PLAN COMMISSION OF THE CITY OF HUDSON, WISCONSIN

TO: Plan Commission
FROM: Community Development
DATE: 2 February 2021
SUBJECT: Discussion and possible action on a downtown design review certificate for 411 Second Street – Creative Color, Inc.

SUBJECT: Discussion and possible action on Riverfront Square concept development plans, preliminary certificate of compliance and preliminary downtown design review at 106 Buckeye Street – Riverfront Properties Inc.

SOUTH ELEVATION

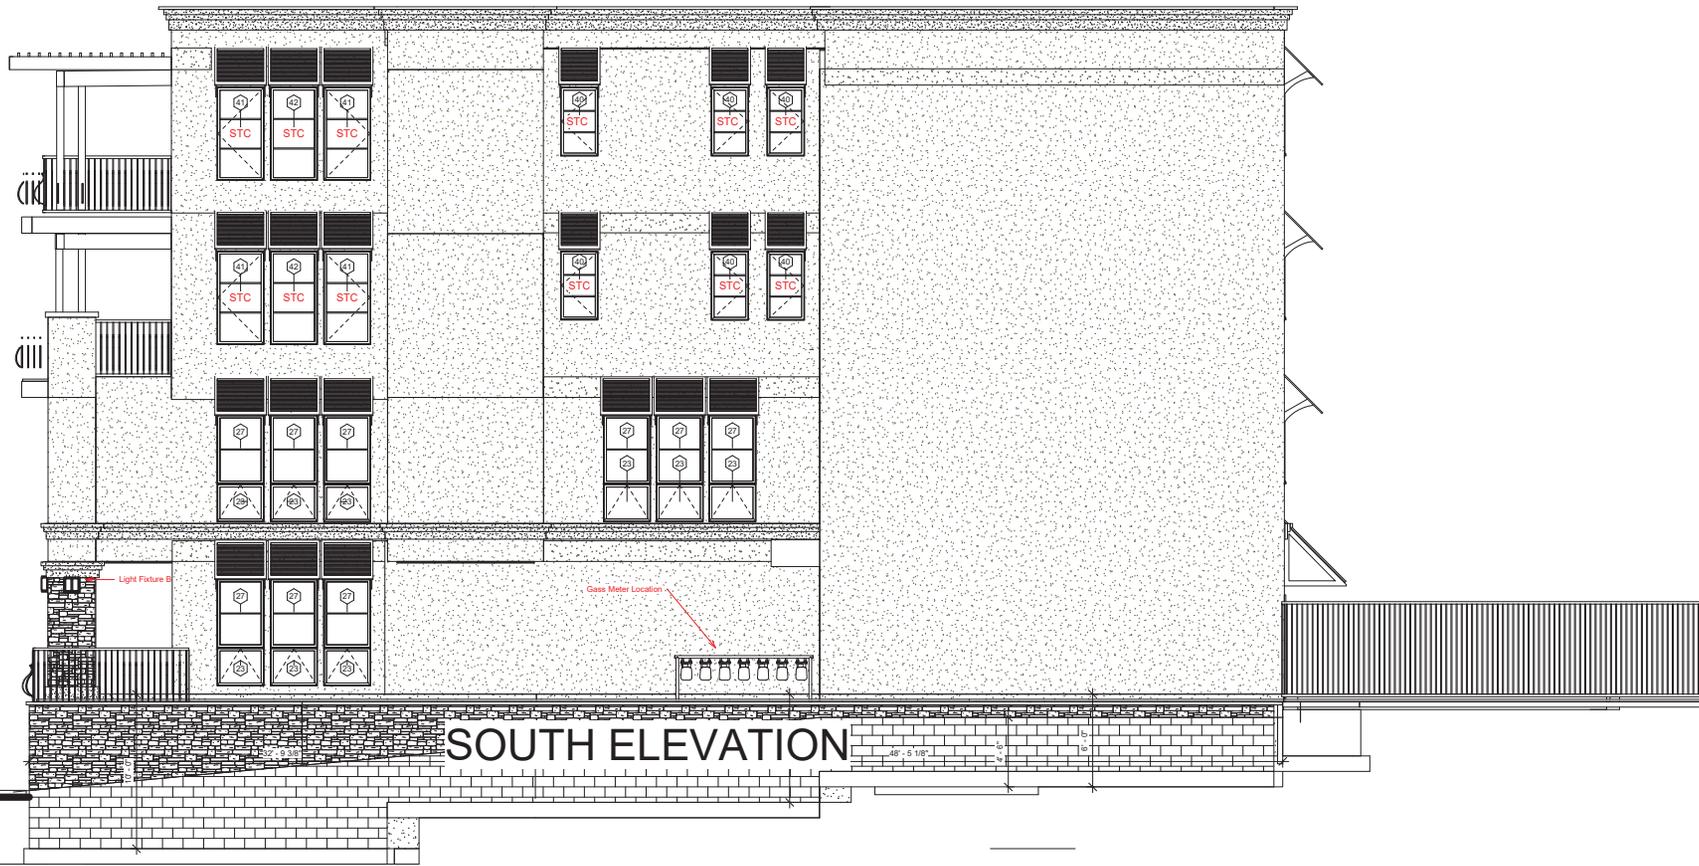
The requirements of [Chapter 255-17.10\(A\)\(5\)\(a\)](#) require the architect to provide ground level expression/distinction through one or more of the following architectural designs: intermediate cornice line, sign band, awning/arcade or portico, change in building materials/texture or detailing, and/or a change in window shape or treatment. The architect explained compliance with this section, stating “*The base of the building has a natural buff/limestone that is naturally seen on St. Croix River bluffs, which sets the stage for the smooth two-tone subdued muddy color, mix of brown, green and gray like the color of tree bark, stucco finish. An intermediate cornice has been added to create a distinct separation from the main level and the floors above. In addition, the North and West façade columns are stone which matches the retaining wall, Black windows and doors with mullions dividing the panes are enhanced with Hurricane shutters on all exterior elevations. The top cornice completes the façade, with black iron railing and layered roof parapet detail.*” In addition to these requirements, there are other design elements noted in [Chapter 255-17.10\(A\)\(5\)\(b\)](#) that require multistory buildings to be designed with a defined base, middle, and top through the use of variations in detailing, color and materials as well as incorporating articulated tops and/or through the use of human scale

GREEN SPACE

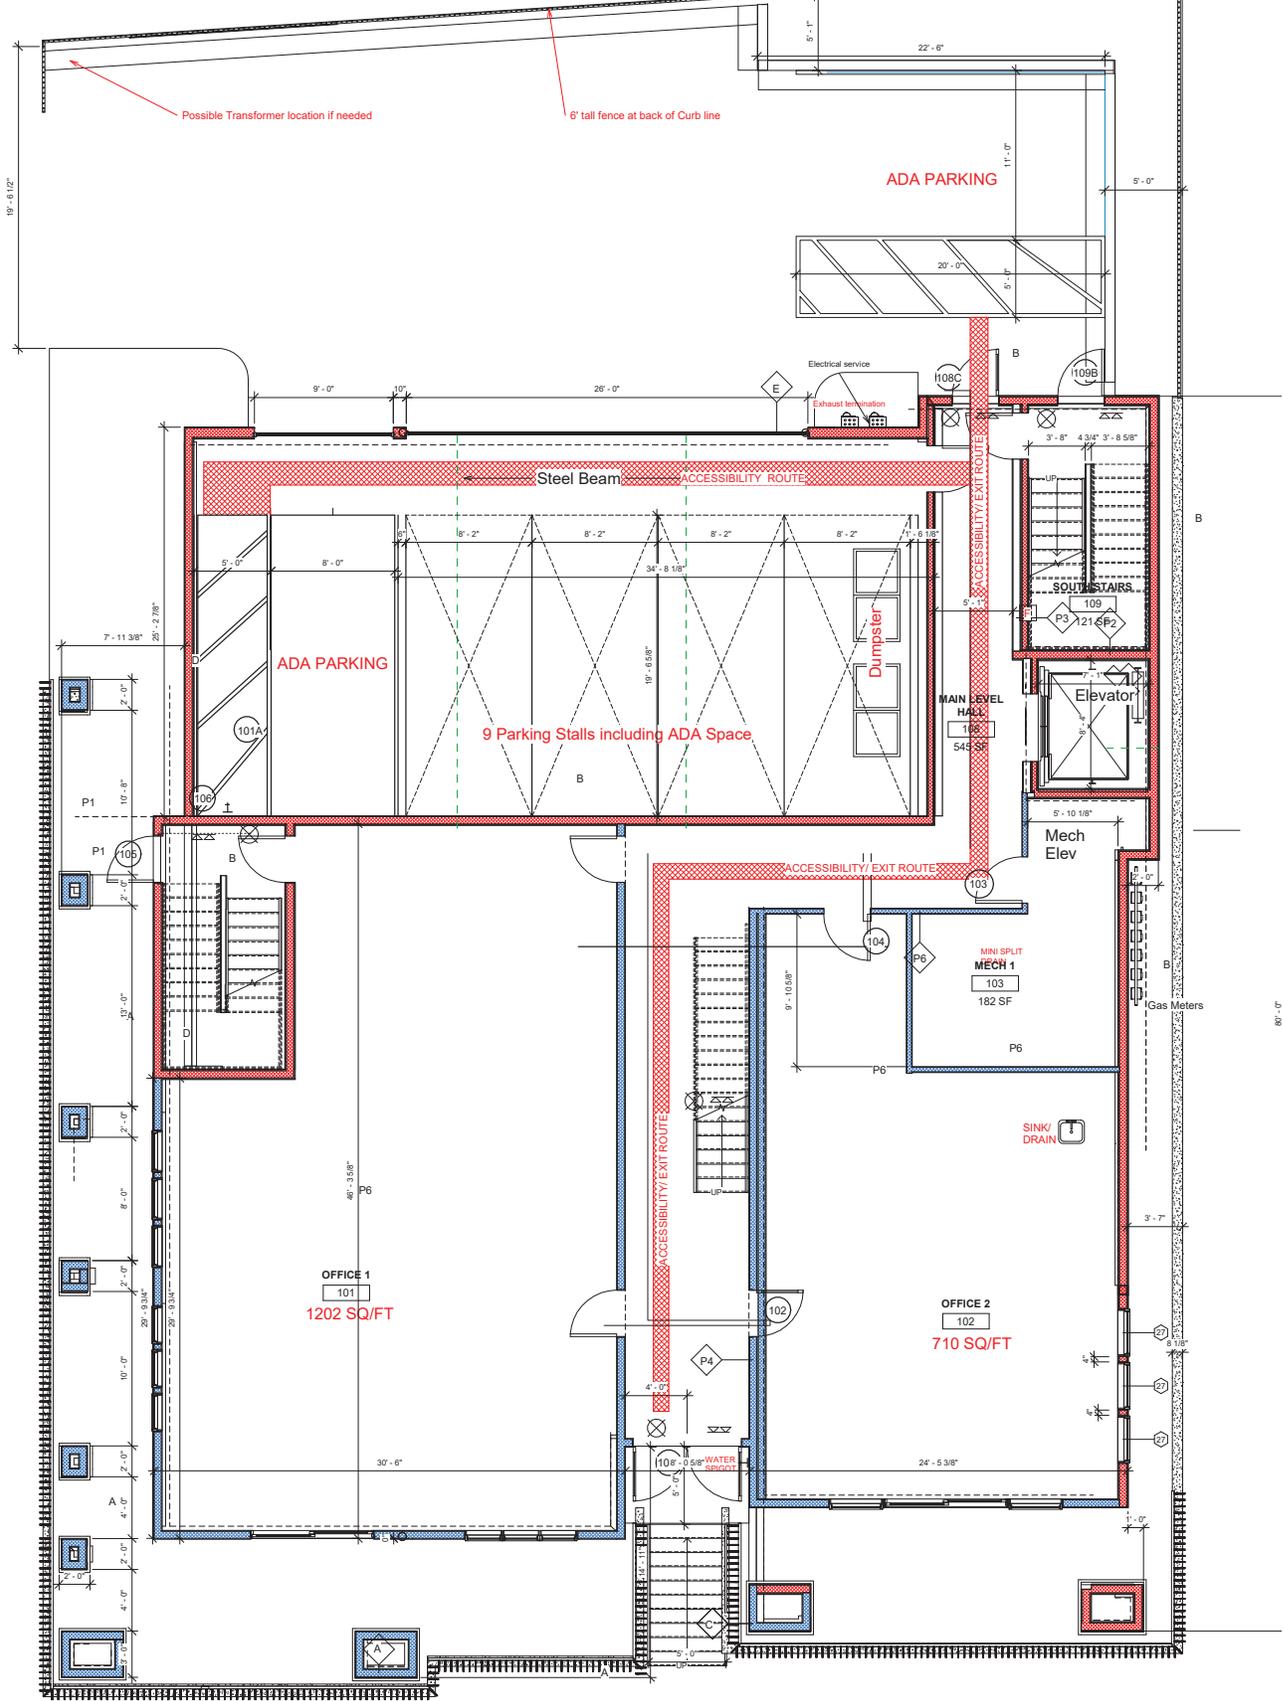
Proposed green space on site will be exactly 20%, with most tree plantings located in the rear of the building and bushes beneath the building overhang. There are planned to be 8 understory trees and 3 overstory trees, equating to an amount of 7 'full' trees. However, [Chapter 255-34\(C\)\(4\)](#) states that "no more than 50% of required trees shall be understory". As each understory tree is counted as 0.5 trees, up to 6 understory trees could be used to fulfill this requirement. Two additional understory trees serve as 'extras' and are not counted as part of this requirement. Additionally, [Chapter 255-34\(C\)\(5\) requires at least 30% of tree plantings to be coniferous. 6 of the trees \(54%\) are planned to be coniferous.](#) The plans also include several trees to be planted outside of the property along the south property boundary. These are not included in the overall tree count. Lastly, Chapter 255-34(C)(6) requires all tree plantings to be at least 15 lineal feet apart. The current landscaping plan does not provide a scale, so staff is unable to calculate whether all trees proposed on site are 15 feet apart or not. Due to this, staff is considering this code section to be unmet at this time.

- 1) That the applicant places a site scale on the landscaping plan prior to final development plan consideration by the Plan Commission and Common Council.
